# Access Compliance Report

### (Curb Ramps)

Intersection ID: 10029652	Main Street: KINGS_CROWN_WY	Cross Street: N/A	Location: SE
ADA ID: AB8B3859F412	Ramp Type: Perp	Initial Pass/Fail: Fail	Overall Compliance: No
Codes/Mitigation Info/Possible Solution		Field Measurements/Component Compliance	
Severity Score: 25

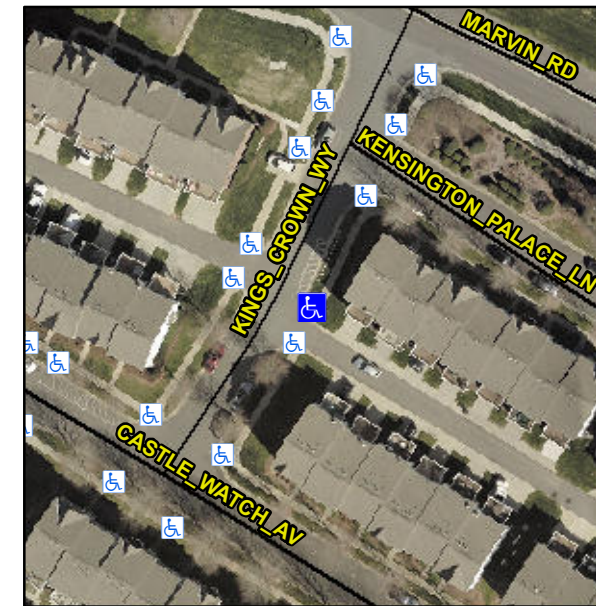
**R304.2.2**

Compliance	Description	Data	Compliance	Description	Data
N/A	Ramp Length (in)	88.0	No	Ramp Slope (%)	19.1
Yes	Ramp Width (in)	49.0	Yes	Ramp XSlope (%)	1.1
N/A	Flare Type LT	N/A	N/A	Flare Type RT	N/A
N/A	Flare Slope LT (%)	N/A	N/A	Flare Slope RT (%)	N/A
N/A	Flare Traversable LT?	N/A	N/A	Flare Traversable RT?	N/A
N/A	Landing Length (in)	N/A	N/A	DWS Provided?	N/A
N/A	Landing Width (in)	N/A	N/A	DWS Contrast?	N/A
N/A	Landing Slope (%)	N/A	N/A	DWS Length (in)	N/A
N/A	Landing X Slope (%)	N/A	N/A	DWS Full Width?	N/A
N/A	Landing Curb? (Y/N)	N/A	N/A	DWS Offset (in)	N/A
N/A	Shared Landing?	N/A			
N/A	Gutter Ponding?	N/A	N/A	Gutter Slope (%)	N/A
N/A	Gutter Lip Ht (in)	N/A	N/A	Gutter X Slope (%)	N/A
N/A	Painted X Walk1?	No	N/A	Painted X Walk2?	N/A
	X Walk 1 Direction	To SW		X Walk 2 Direction	N/A
N/A	X Walk 1 Width (in)	N/A	N/A	X Walk 2 Width (in)	N/A
	X Walk 1 Slope (%)	1.5		X Walk 2 Slope (%)	N/A
	X Walk 1 X Slope (%)	3.1		X Walk 2 X Slope (%)	N/A

**Remove & Replace Entire Ramp.**
